Addendum No. 001

Subject: 2020 Classroom Modernizations

Location: John Welsh School

This Addendum, dated February 28, 2020, shall modify and become part of the Contract Documents for the work of this project. Any items not mentioned herein, or affected by, shall be performed strictly in accordance with the original documents.

OVERALL FIRST FLOOR DEMOLITION PLAN

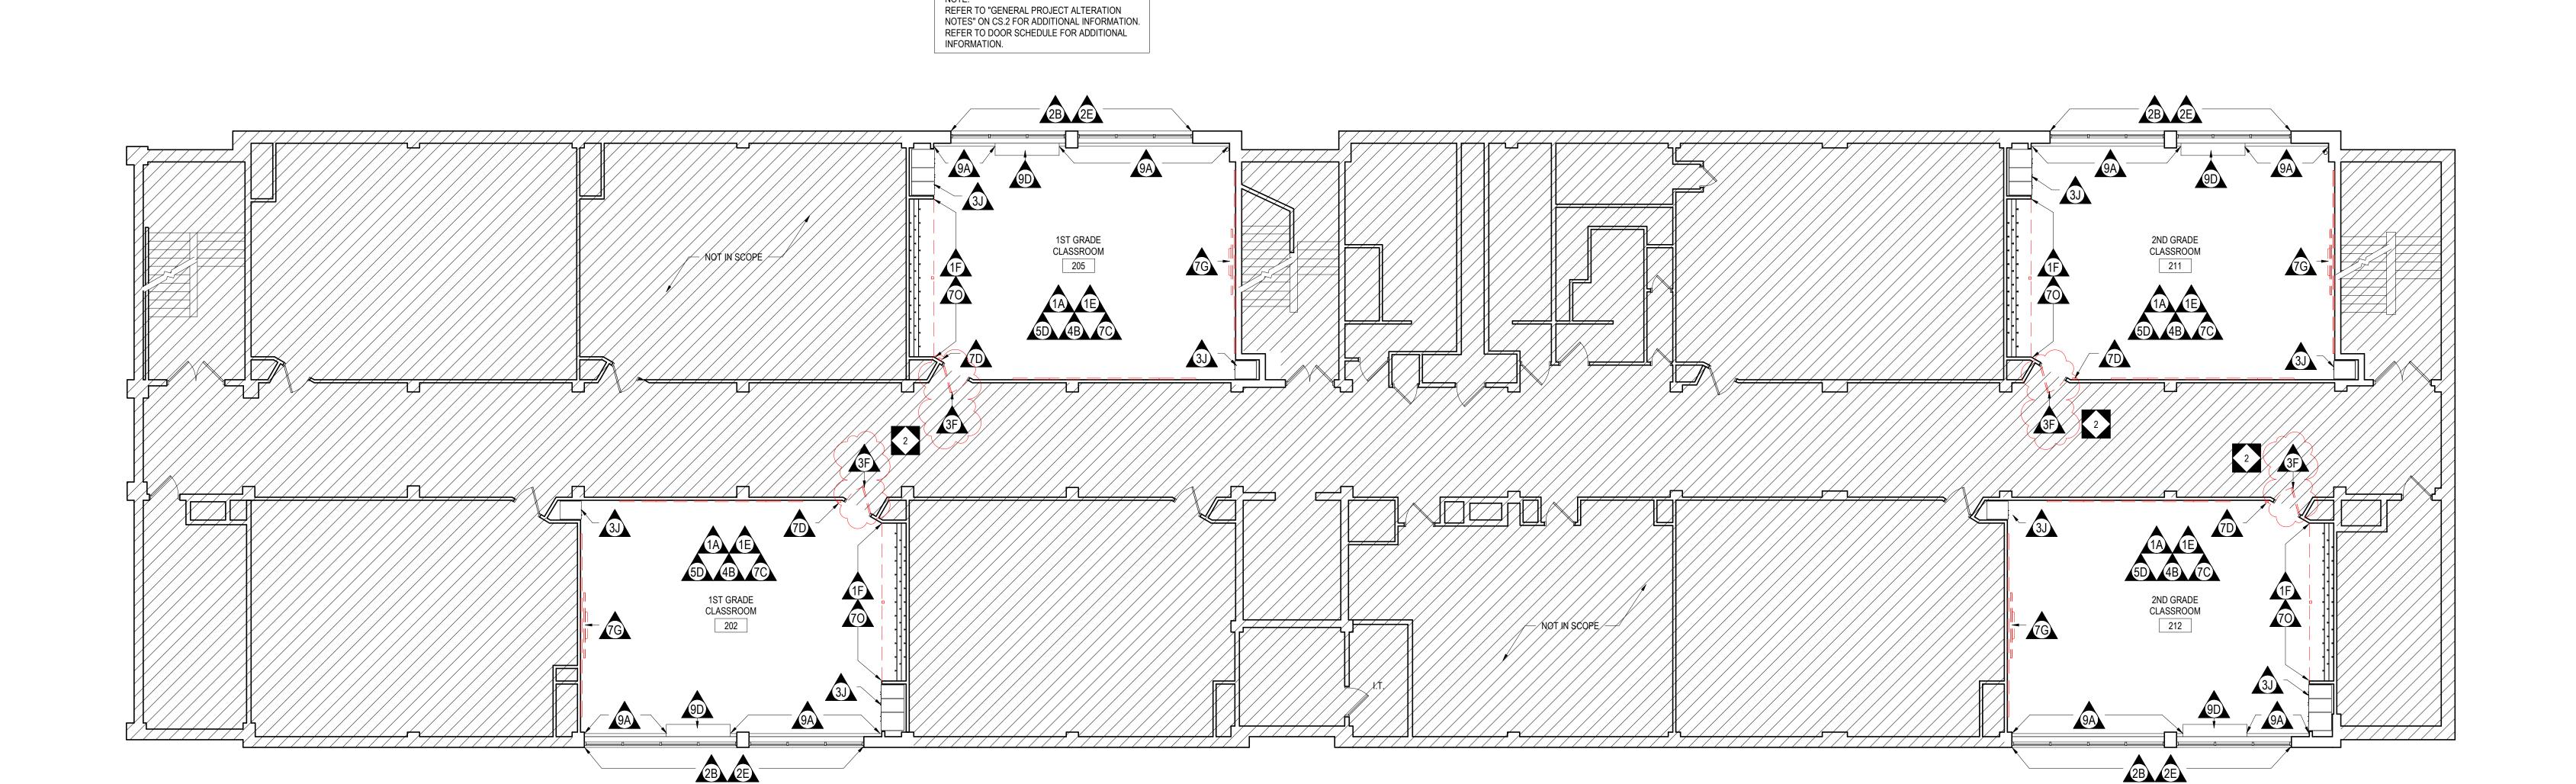
- 1. REVISE plan 1/D1.1. Existing visual display to remain on corridor wall in rooms 100 & 102.
- 2. CLARIFY only demolish visual display on plan west wall of room 100 and plan east wall of room 102 (demolition note 7C).
- 3. ADD demolition note 3F as indicated on the drawings.

OVERALL SECOND FLOOR DEMOLITION PLAN

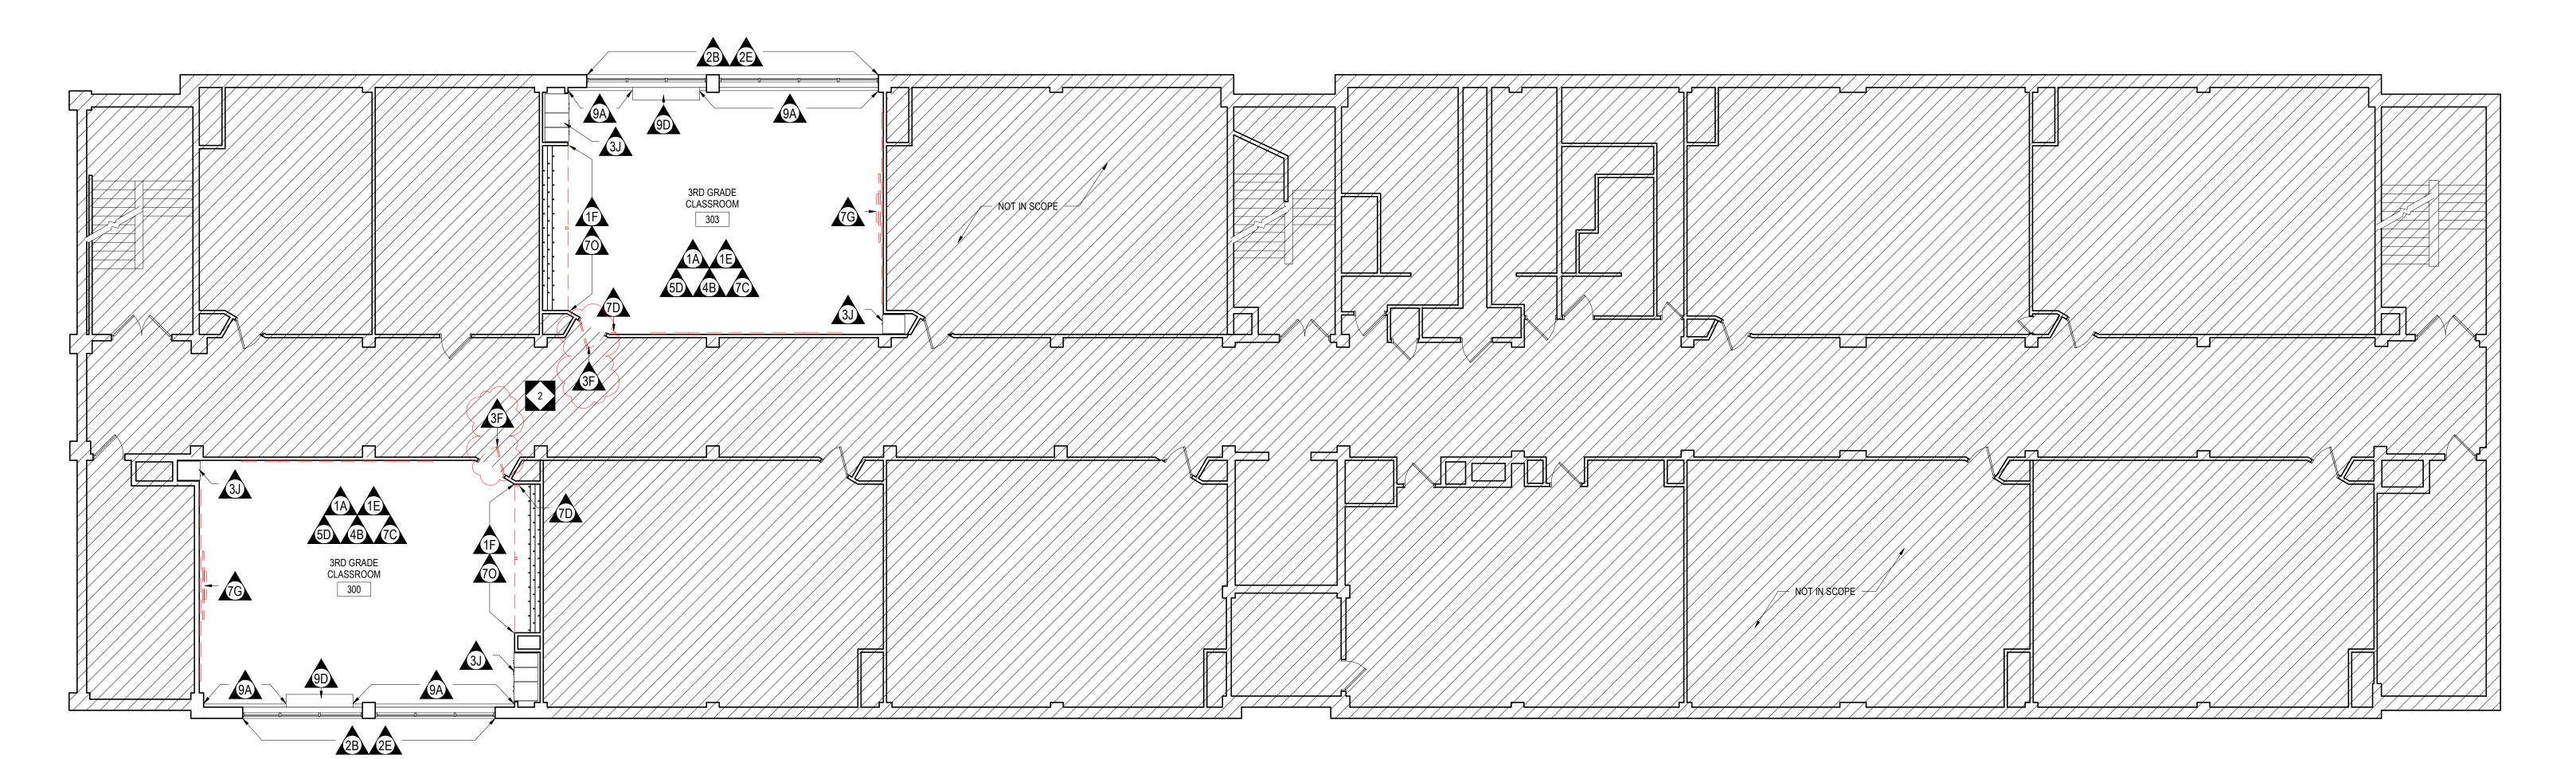
1. ADD demolition note 3F as indicated on the drawings.

OVERALL THIRD FLOOR DEMOLITION PLAN

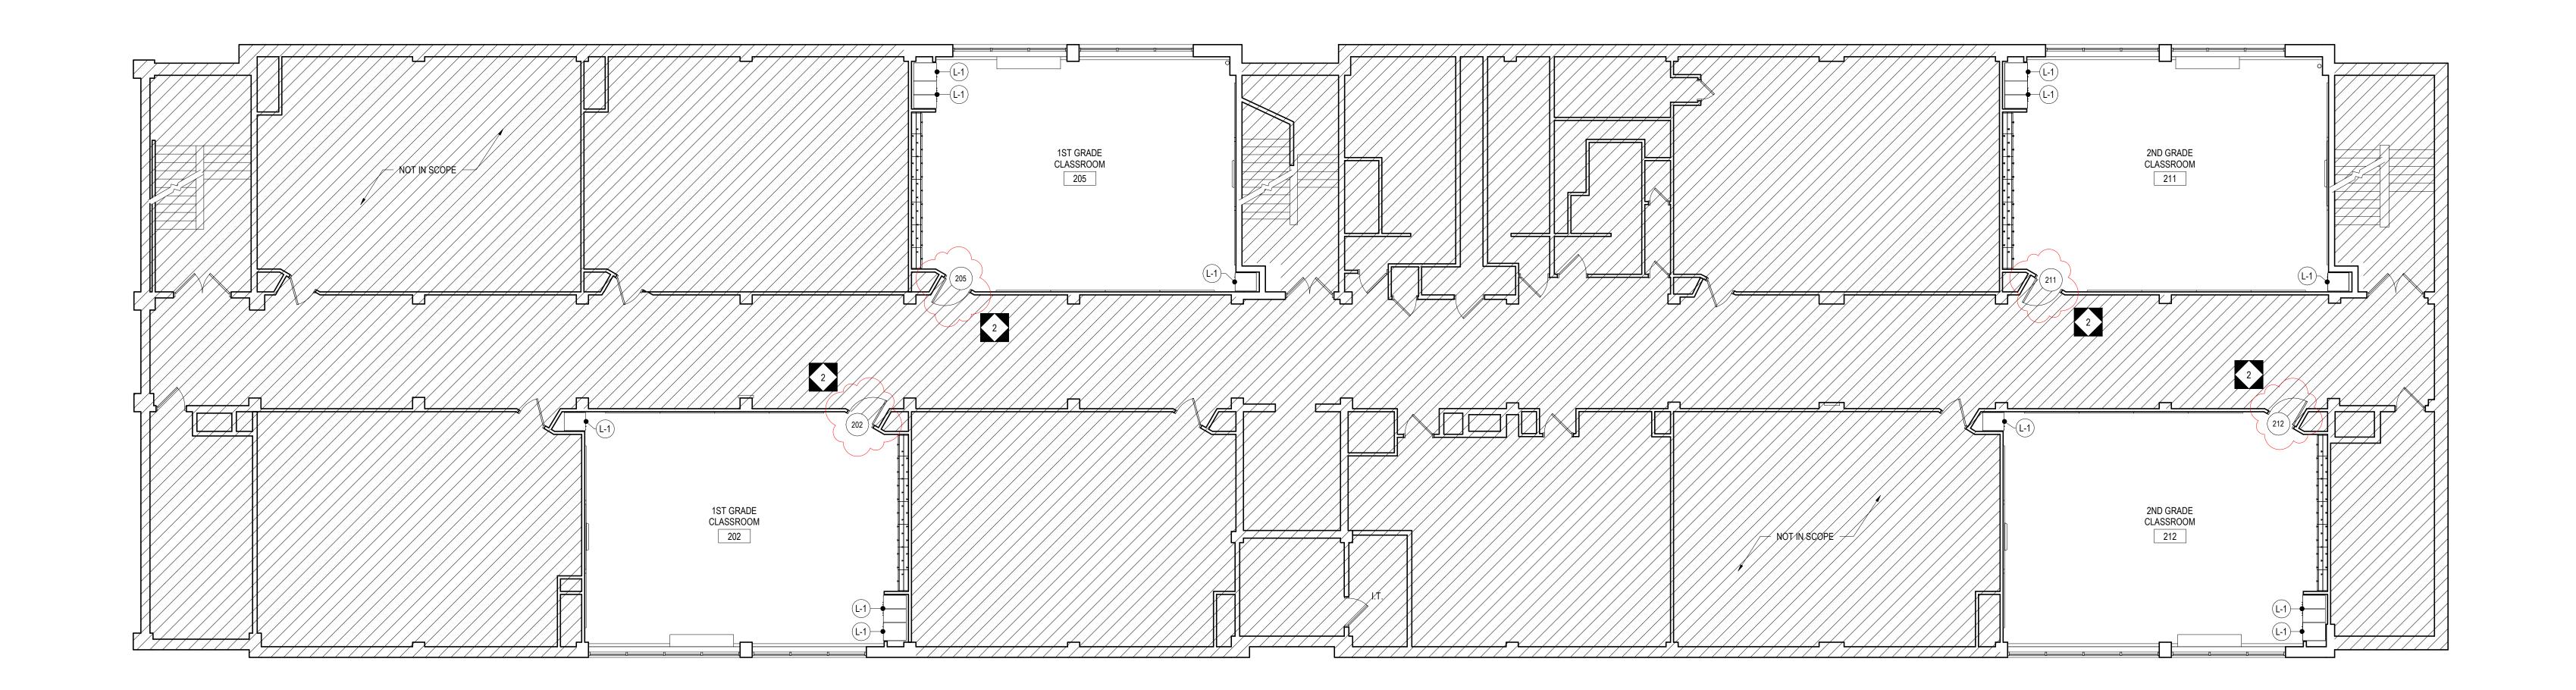
1. ADD demolition note 3F as indicated on the drawings.

1 OVERALL THIRD FLOOR PLAN
A1.3 1/8" = 1'-0"

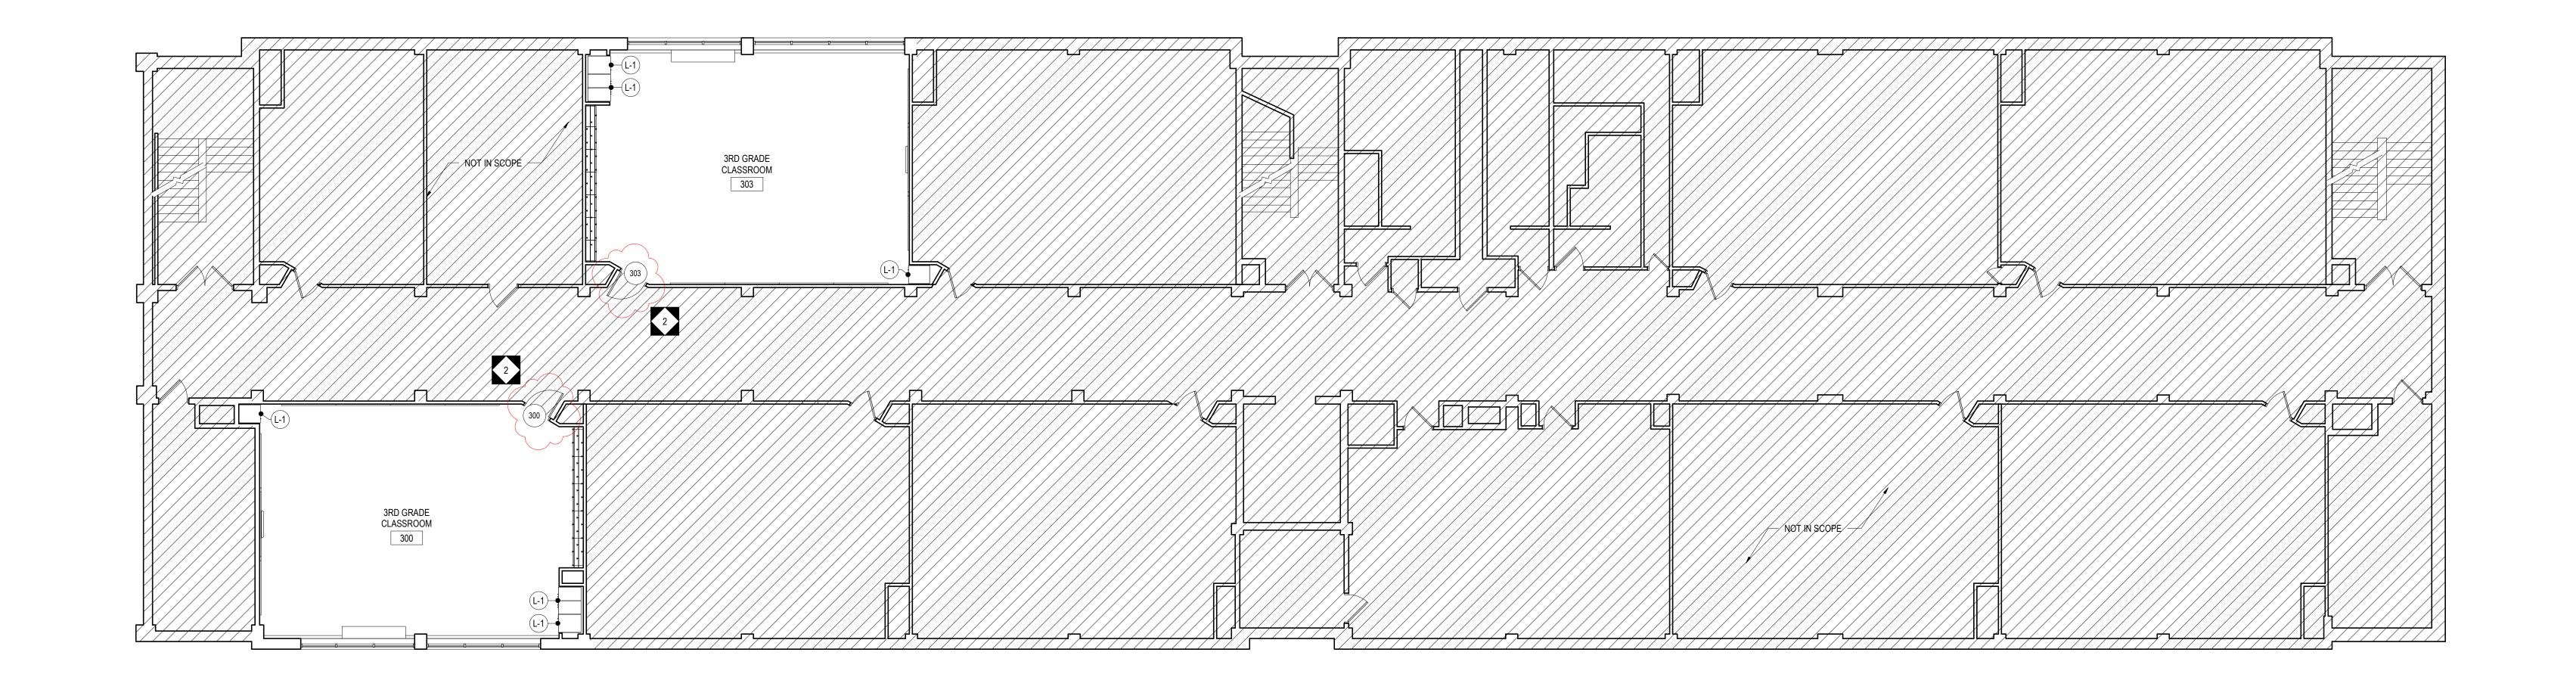
1. REVISED plan 1/A1.3 to show doors 300 and 303 as new, as indicated on drawings.
